SERVICE No. 671 BULLETIN

Piper Aircraft Corporation

Subject: Flap Control System Inspection and Reinforcement

PA-23/PA-23-160 Apache
PA-23-235 Apache
PA-23-250 Aztec
PA-23-250 (6 Place) Aztec

SKETCH A

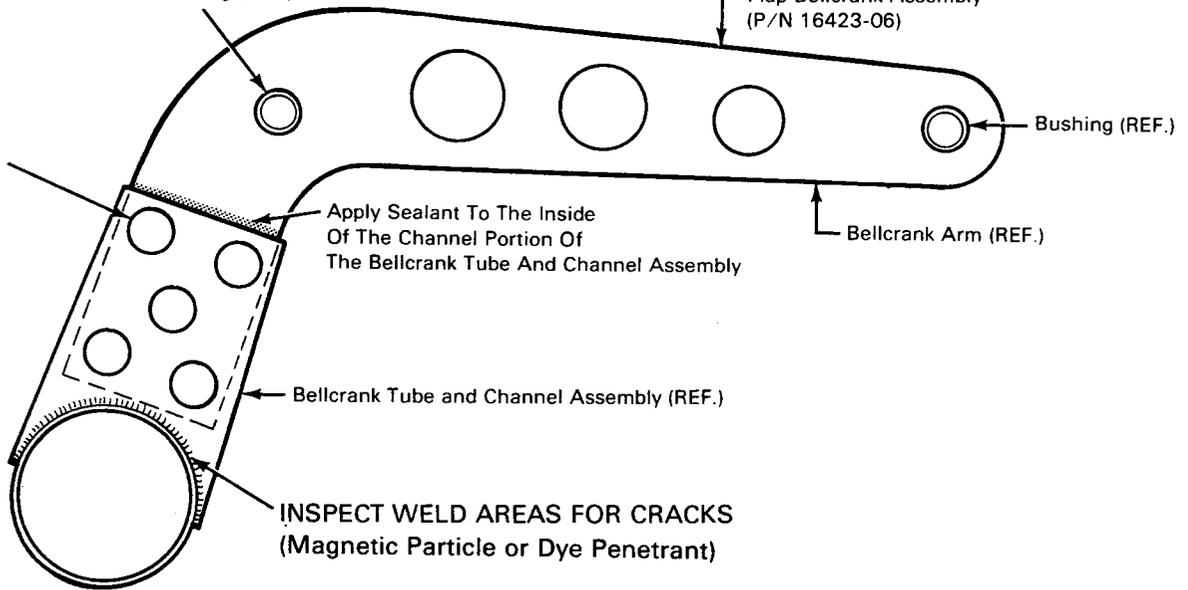
2. Remove the left and right rear wing root fairings and the left and right flap torque tube access panels. Refer to sketch "A".
 3. Disconnect the push-pull control rods from the flaps by removing the attachment hardware at the inboard flap rib.

4. Refer to sketch "A". Remove the flap bellcrank assembly from the right side of the flap torque tube by disconnecting the hydraulic flap actuator cylinder and the push-pull control rod and removing the bellcrank attachment hardware from the torque tube. Refer to sketch "B" and proceed as follows.

FLAP BELLCRANK DETAIL

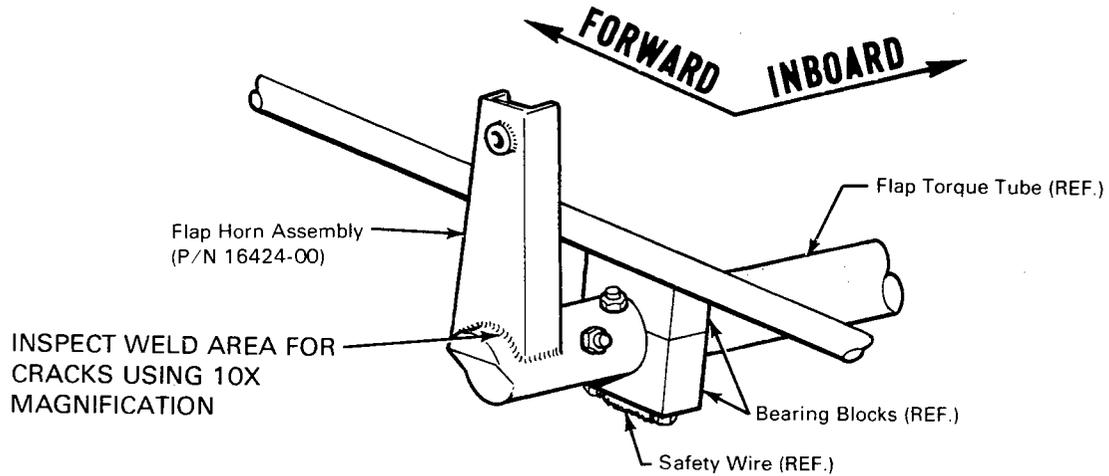
- a. Remove the five (5) rivets which attach the bellcrank arm to the bellcrank tube and channel assembly and remove the arm from the channel.
 - b. Remove all paint and corrosion from the inside and outside of the bellcrank tube and channel assembly to facilitate inspection.

- c. Inspect the bellcrank tube and channel assembly, in the weld area, for cracks using the magnetic particle or dye penetrant inspection method as described in the F. A. A. Aircraft Inspection and Repair Manual A. C 43. 13-1A, Chapter 7, Section 3. Also clean and check general condition of bellcrank arm.

- d. If a crack or excessive corrosion is found, replace with new flap bellcrank assembly (P/N 16423-06) as described in the Drilling Procedure for Replacement of Flap Bellcrank Assembly and Flap Horn Assembly on page 3.

- e. If no crack or excessive corrosion is found, reassemble bellcrank as follows:
 1. Apply sealing compound RTV-102 or PRC 1221-B2 (Piper P/N 914 046 - 6 oz. or P/N 914 047 - 2.5 oz.) or equivalent to the inside of the channel portion of the bellcrank tube and channel assembly.

2. Insert the bellcrank arm into the bellcrank tube and channel assembly. Remove excess sealant. NOTE: Assemble arm in proper direction. Refer to sketch "A".

3. Fasten the bellcrank arm to the channel using five (5) rivets (P/N 420 252/MS20470AD6-12).
 4. Prime and repaint the bellcrank assembly.
- NOTE: When Bellcrank, Piper Part No. 16423-00 is reassembled in accordance with Instruction 4, step e, a visual inspection of the bellcrank must be repeated at intervals not to exceed 100 hours time in service after initial inspection of Instruction 4.

FLAP HORN DETAIL
(View Looking In From Left Side)

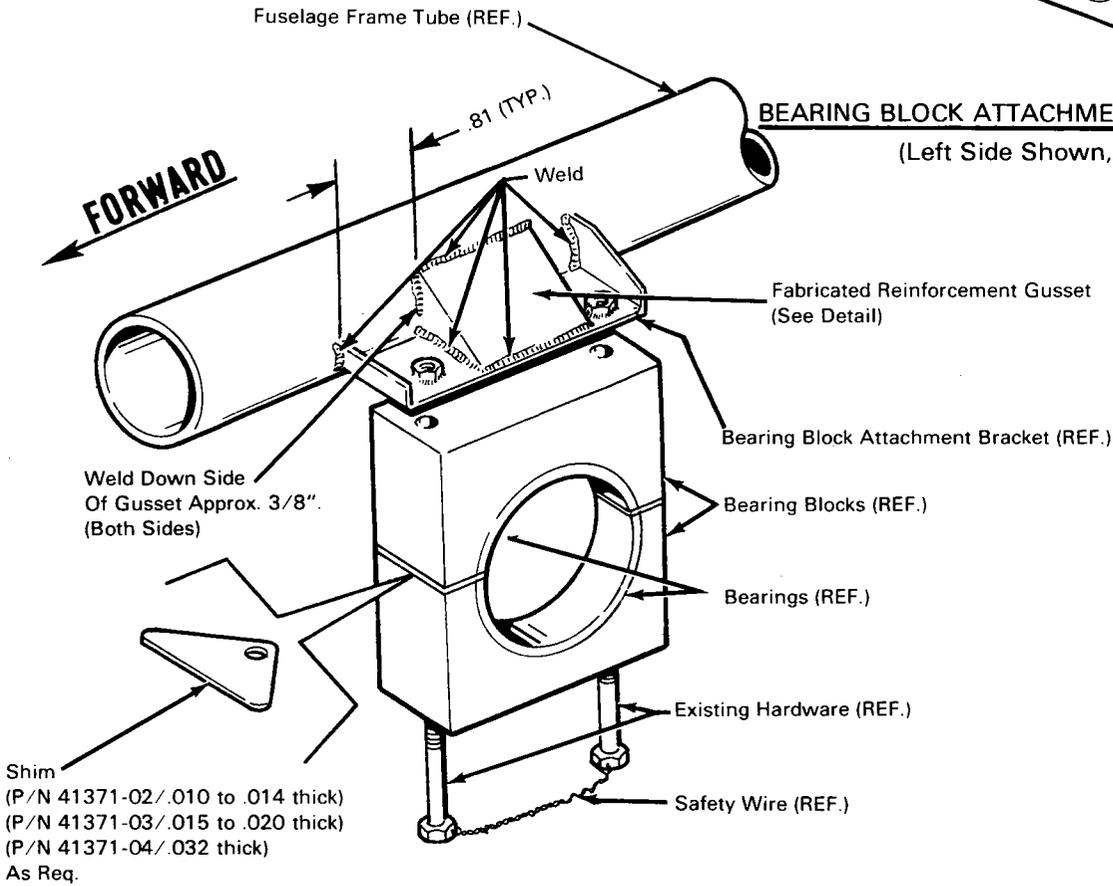
6. Refer to sketch "B". Inspect the weld on the flap horn assembly for cracks using 10X magnification.
 - a. If cracks are found, replace with new flap horn assembly (P/N 16424-00) as described in the Drilling Procedure for Replacement of Flap Bellcrank Assembly and Flap Horn Assembly on page 3.

BEARING BLOCK ATTACHMENT BRACKET INSPECTION DETAIL
 (Left Side Shown, Right Side Opposite)

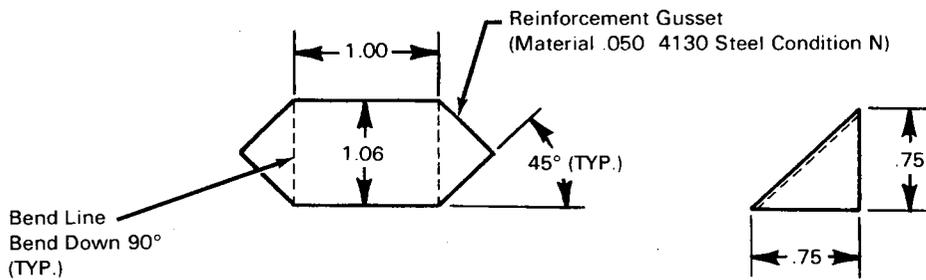
7. Refer to sketch "C". Remove paint and inspect the torque tube bearing block attachment brackets, which are welded to the fuselage frame tube, for cracks using 10 X magnification.

- a. If cracks are found, repair or replace with new bearing block attachment bracket (s) (P/N 28624-03 on left side - P/N 28624-02 on right side). NOTE: New right side bracket assembly (P/N 28624-02) will include the reinforcement gusset being added per step 9. If new right side bracket (P/N 28624-02) is being installed, disregard step 9 in its entirety.

REINFORCEMENT GUSSET INSTALLATION DETAIL
 (Right Side Only)

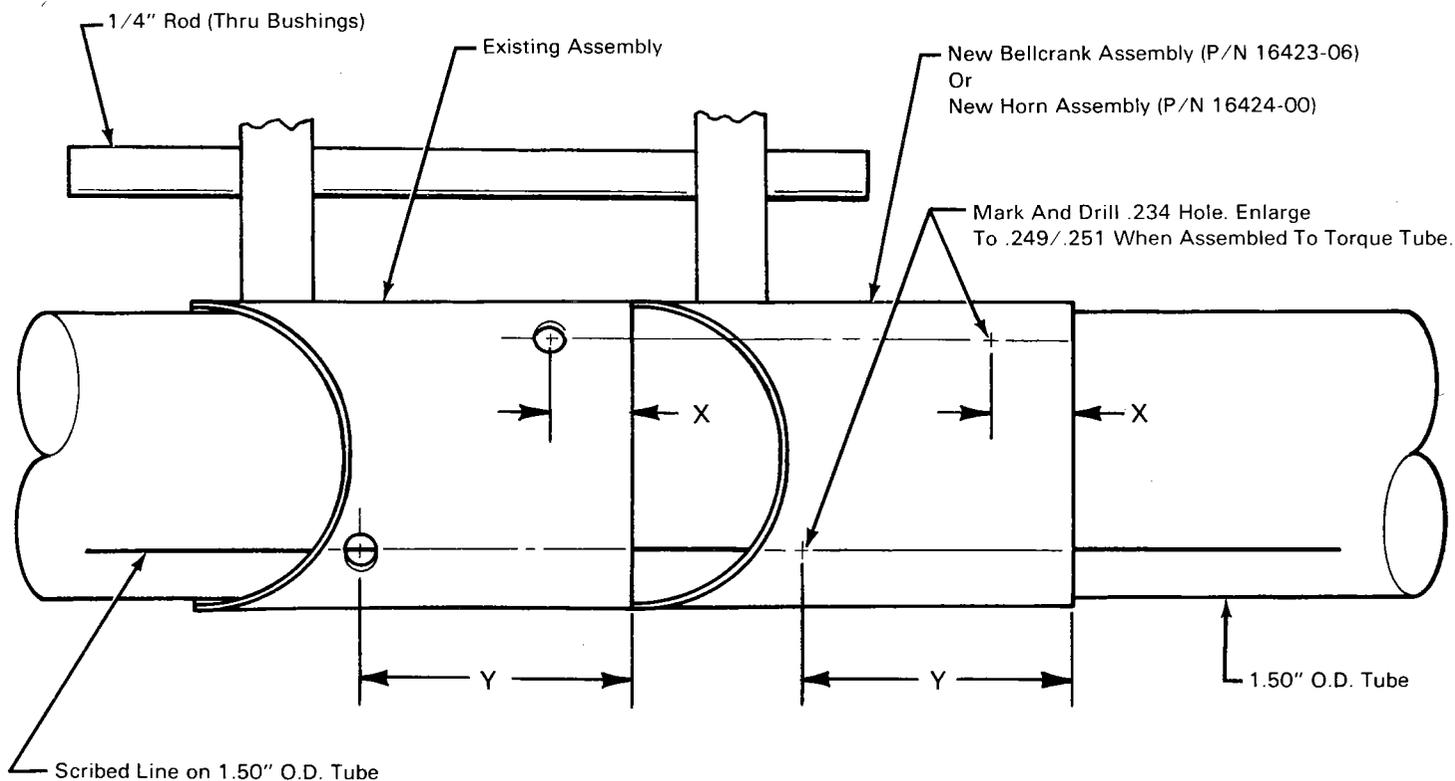
9. Refer to sketch "C". Add a reinforcement gusset to the flap torque tube bearing block attachment bracket on the right side as follows:

- b. Lower the torque tube assembly to facilitate installation of a reinforcement gusset on the right side bracket.
 - c. Fabricate a reinforcement gusset, as shown on sketch "C", using .050 4130 steel condition N.

- d. Position the reinforcement gusset between the two nuts on the bearing block attachment bracket as shown on sketch "C".
 - e. Weld the reinforcement gusset to the fuselage frame tube and the bearing block attachment bracket using the gas welding method. NOTE: Take all precautions against the hazard of fire. Use a flameproof material to cover the flap torque tube, fuselage skins, structures, etc.
